Addendum

Distribution	<input checked="" type="checkbox"/> Owner	<input checked="" type="checkbox"/> Consultant(s)	<input checked="" type="checkbox"/> Bidders	<input type="checkbox"/> Other ..
From	Mariela Flores, AIA, NCARB Page Southerland Page, Inc. 1100 Louisiana, Suite One Houston, TX 77002	Owner	Cypress Fairbanks Independent School District	
Project	2024 Cy Ridge HS Renovations RFP 24-02-5752-R-RFP	Architect's Project No.	33AC23221	
Date of Issue	7-January-2025	Addendum No.	004	
Contract For	General Construction	For Bids Due	9-January-2025

Description ADDENDUM NO. 4, Issue for Proposals Drawings and Specifications dated December 9th, 2024 Cy Ridge HS Renovations; as prepared by PSP, 1100 Louisiana, Suite one, Houston, Texas

SHEET NUMBER
ADC-101

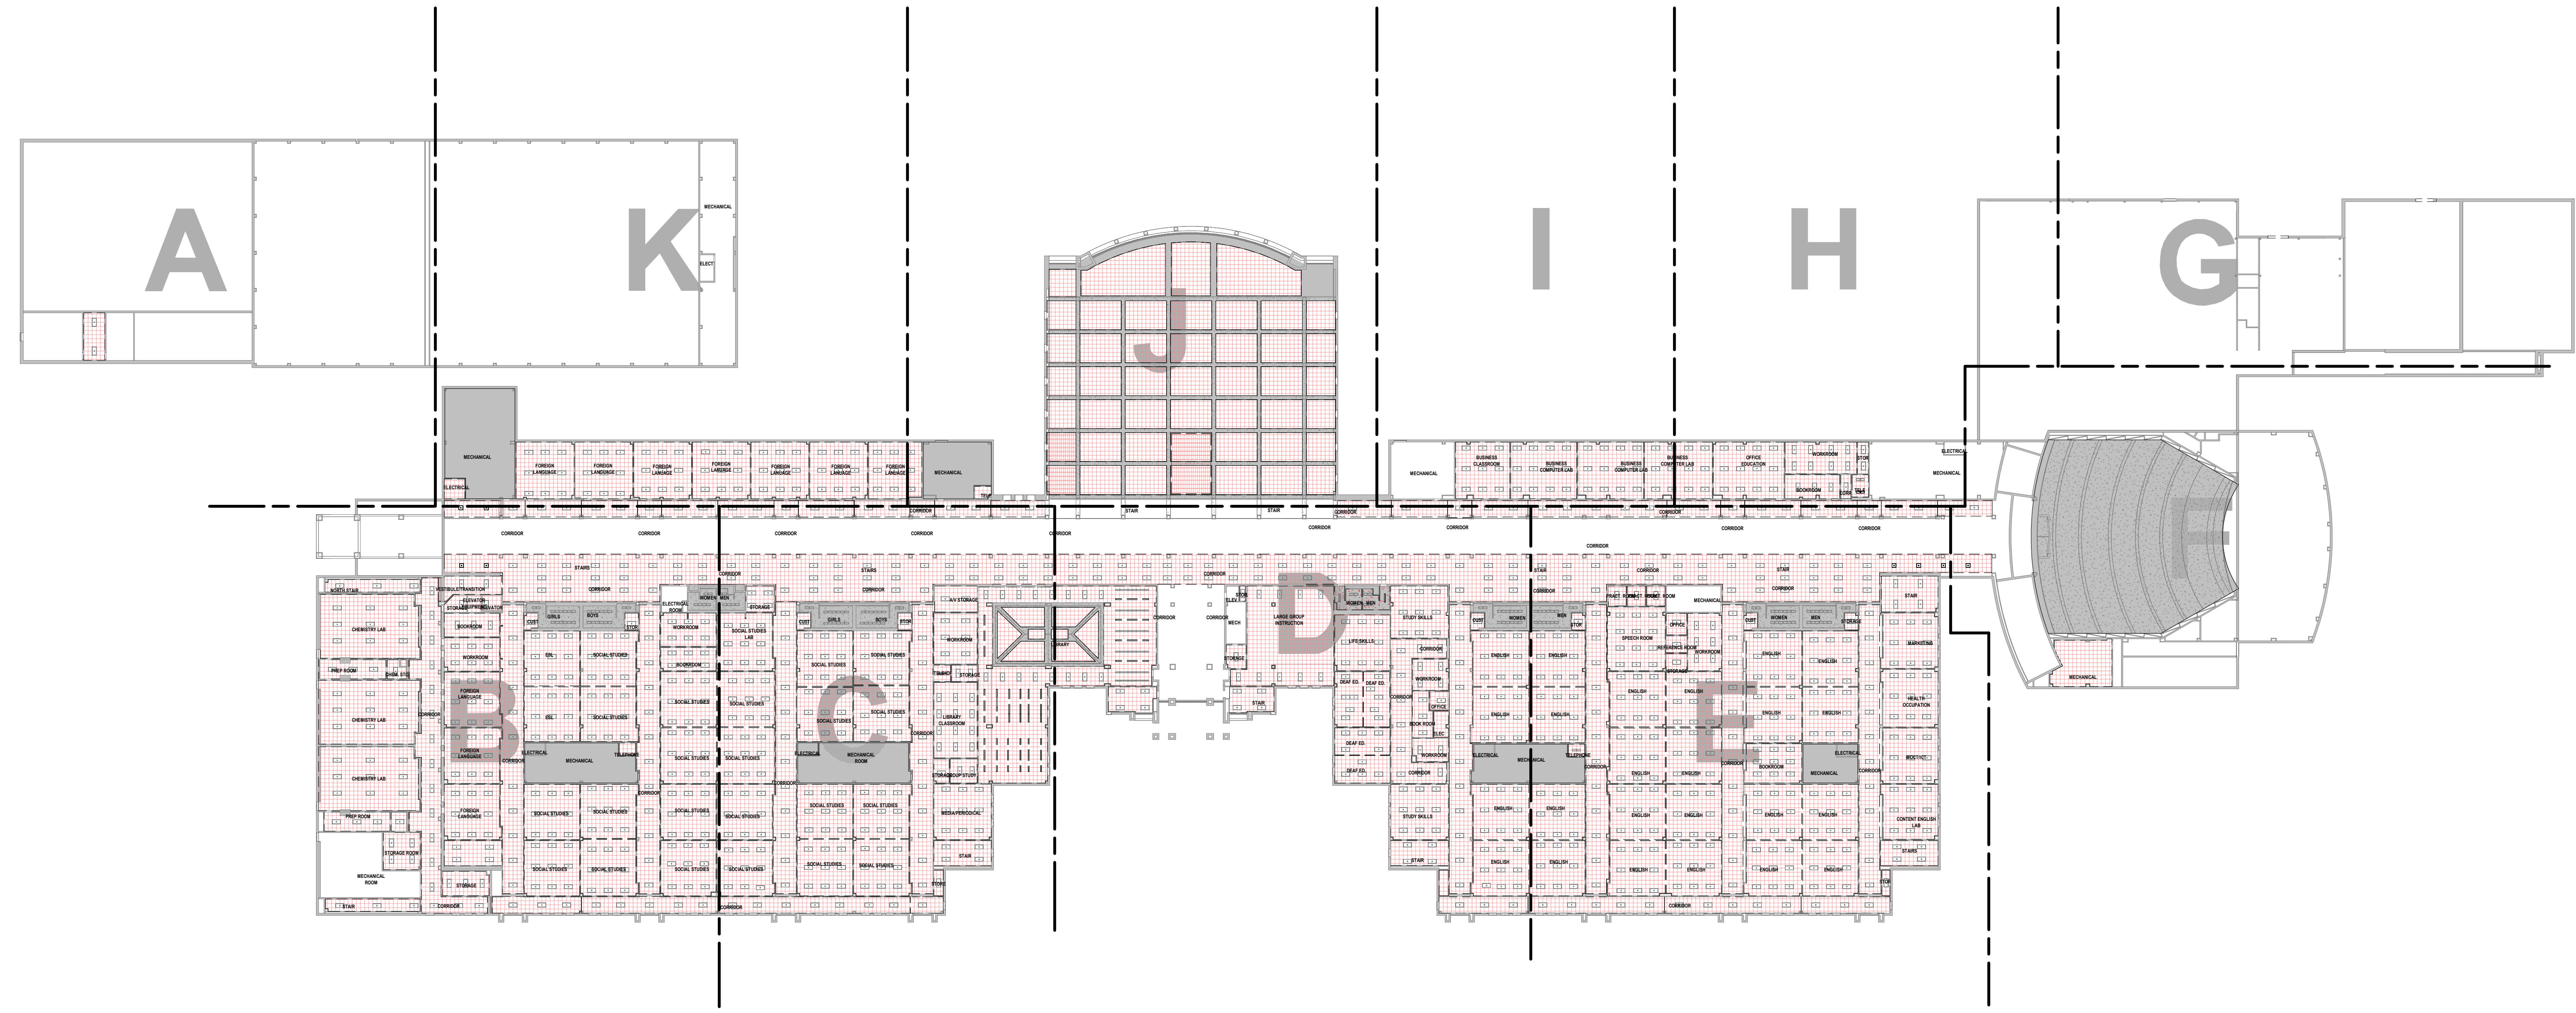
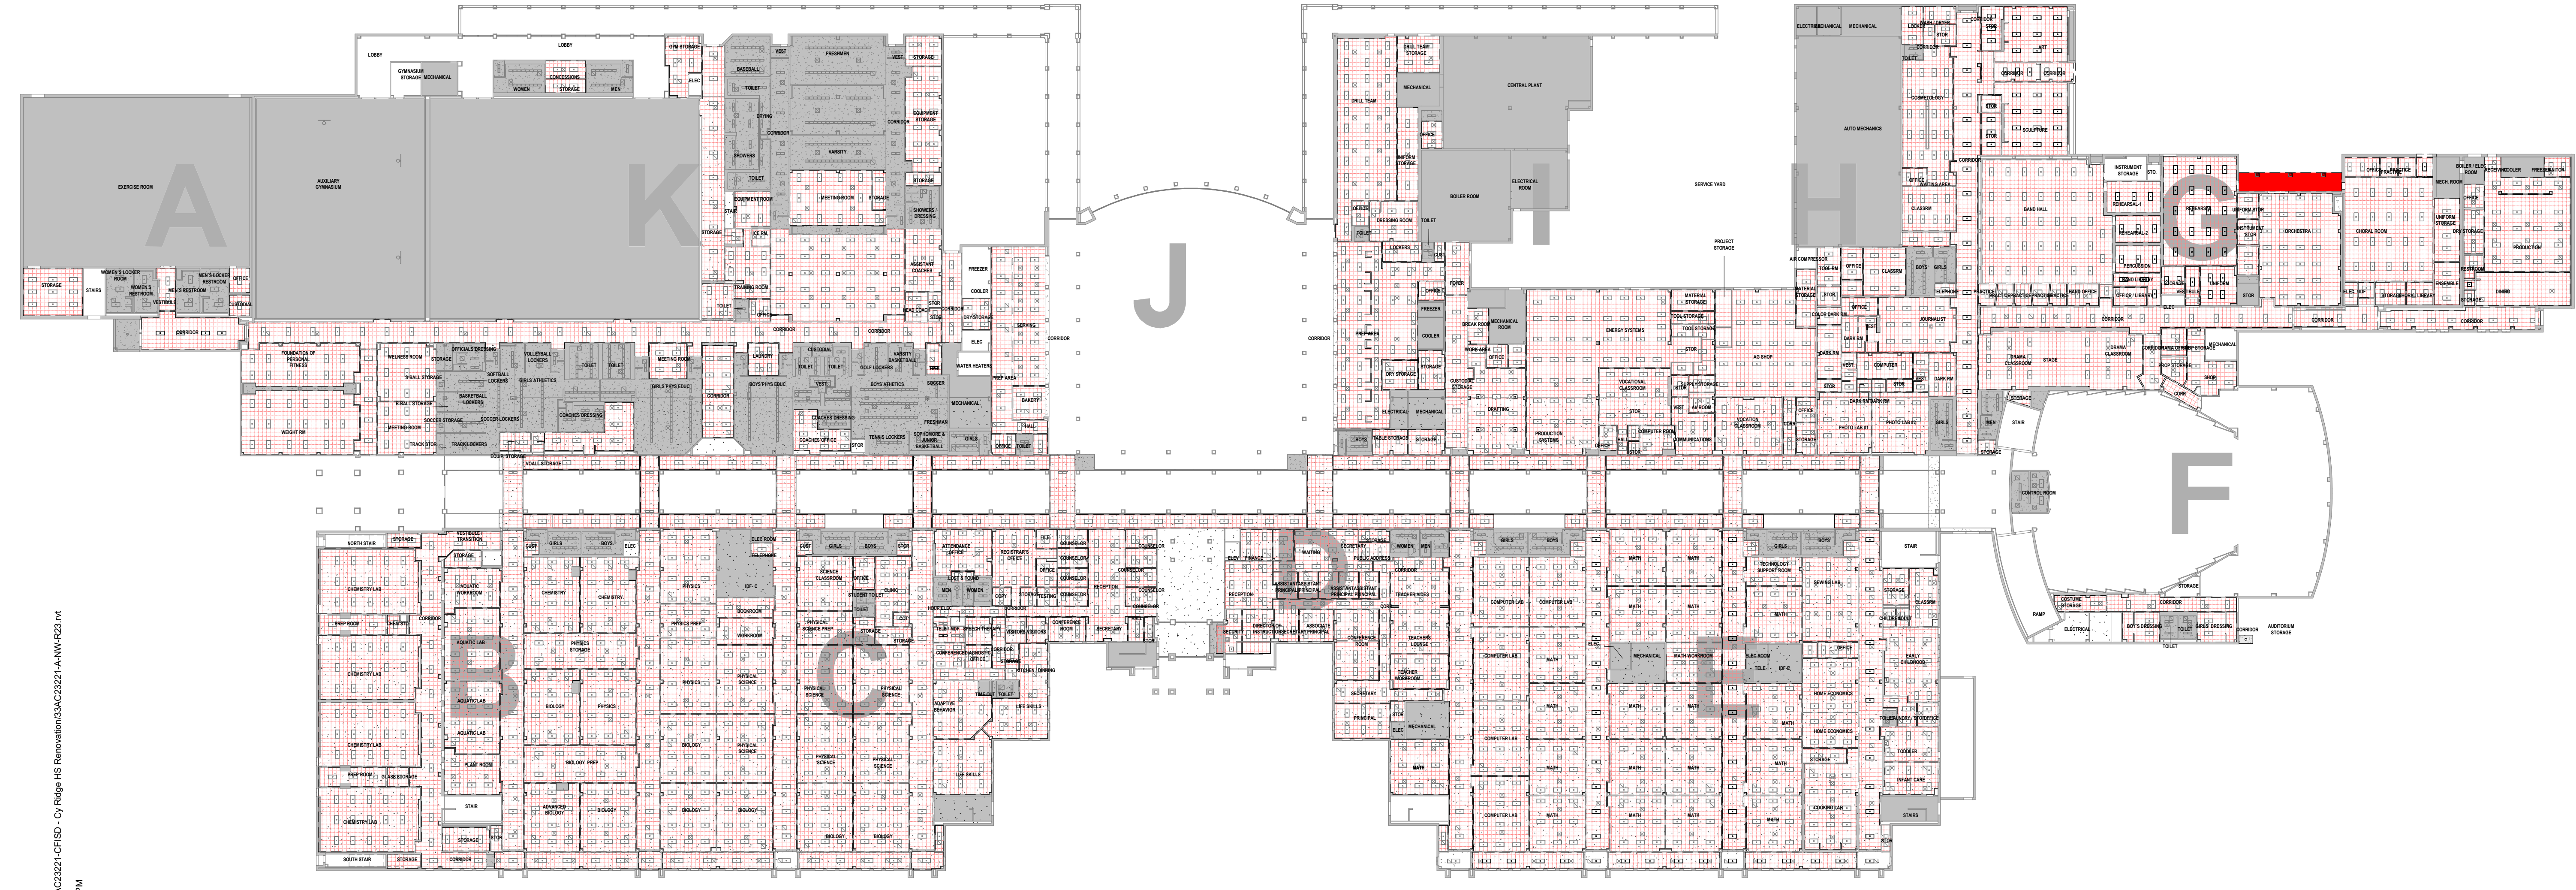
ARCHITECTURAL			
ADC-101	01/07/2025	NEW	ARCHITECTURAL – DEMO REFLECTED CEILING PLAN - LEVEL 01 & 02 Add the sheet in its entirety Added to provide clarity on the extent of ceiling demolition
